**U.S. Army Corps  
of Engineers**  
Engineering and Support  
Center, Huntsville

## **TRAINING SUPPORT CENTER**

**Building 77680  
Fort Riley, KS**

**POTR – Phase 1  
Project No 19389**

SECTION OF PAGE JTT-112  
PARTIAL FLOOR PLAN -  
COMMUNICATIONS

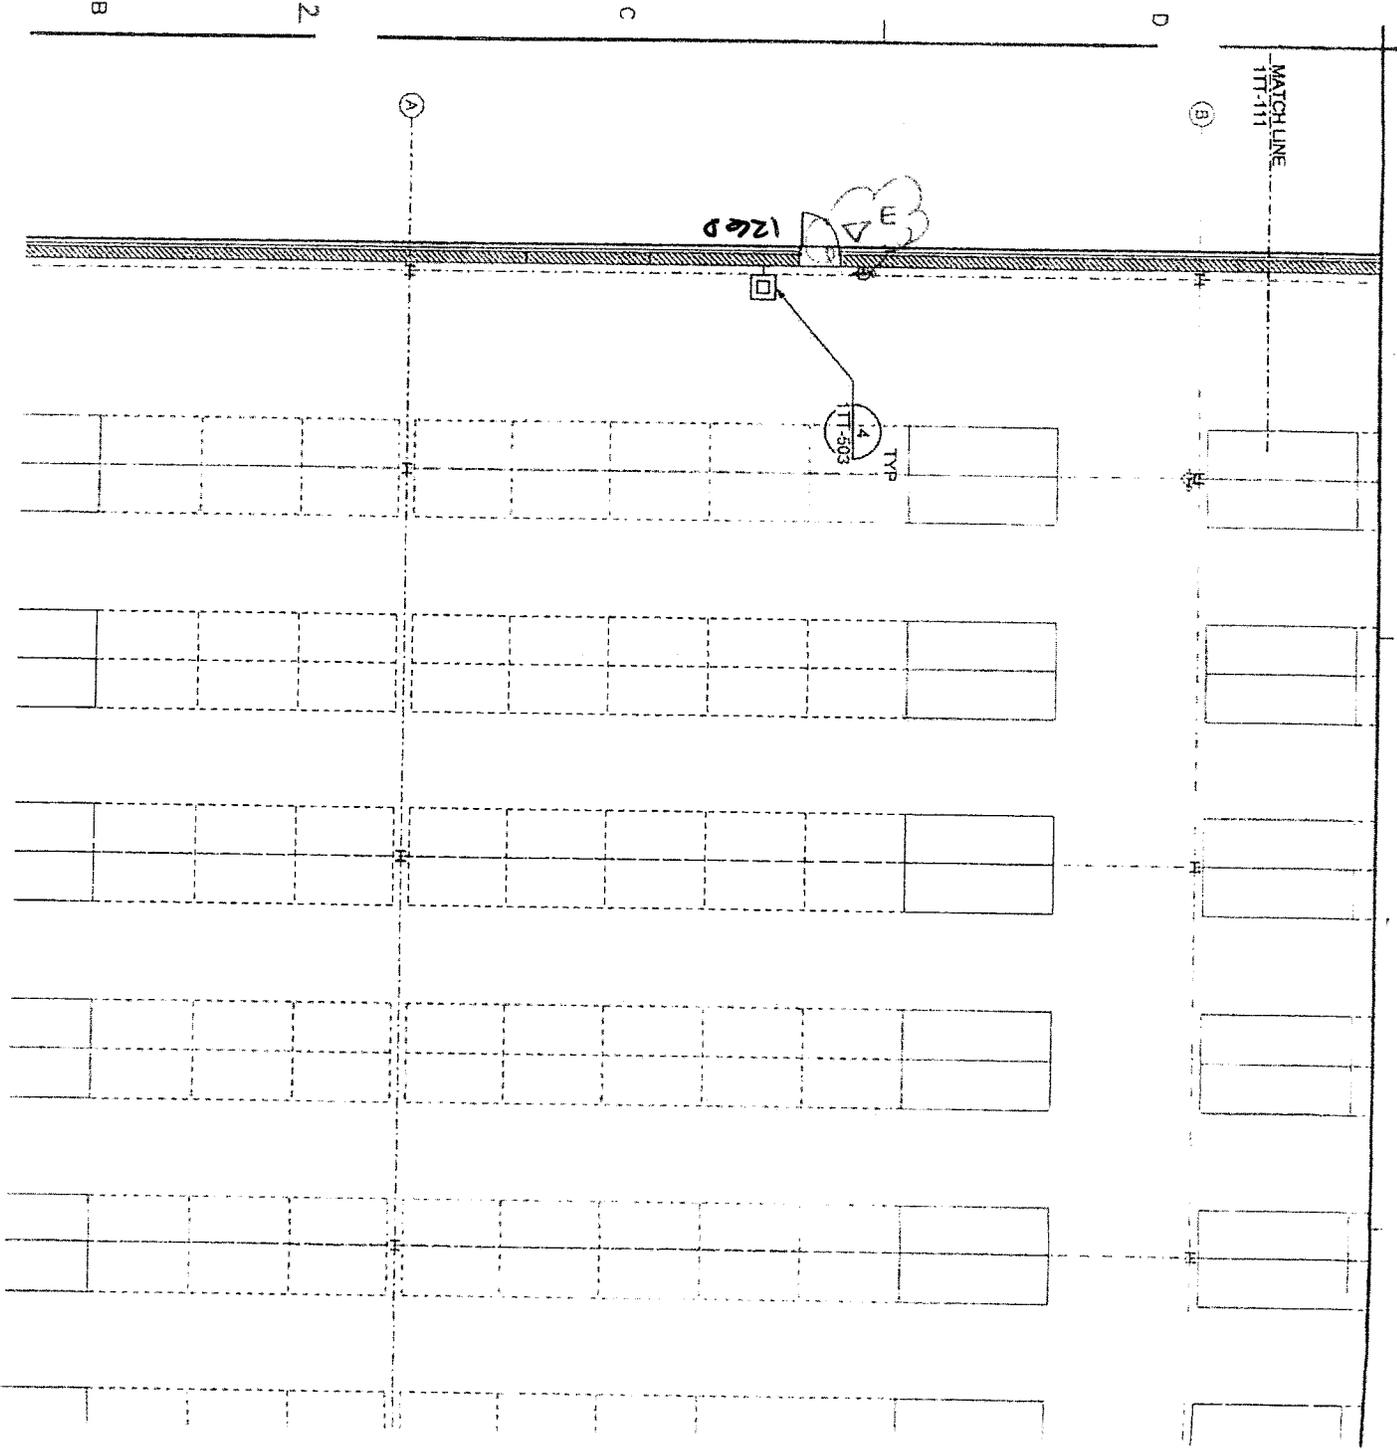
In accordance with the Contract Clause, "Changes", we request a proposal to perform the following work. This pending change may be referenced as MK006, "Additional Telecom Outlets".

Contractor shall provide materials, labor, and equipment to install three additional telecommunications outlets with conduit and cable on the building exterior walls adjacent to doors in rooms 104 - classroom, 101 - Vest, and 126 - warehouse, with the following characteristics: One (1)- 4 pair category six cable for wall mounted exterior telephone; route cable in 1" conduit from device to the cable tray. Extend cable in cable tray back to communications room #106 or room #130. Refer to sheet 1TT-502 for detail.
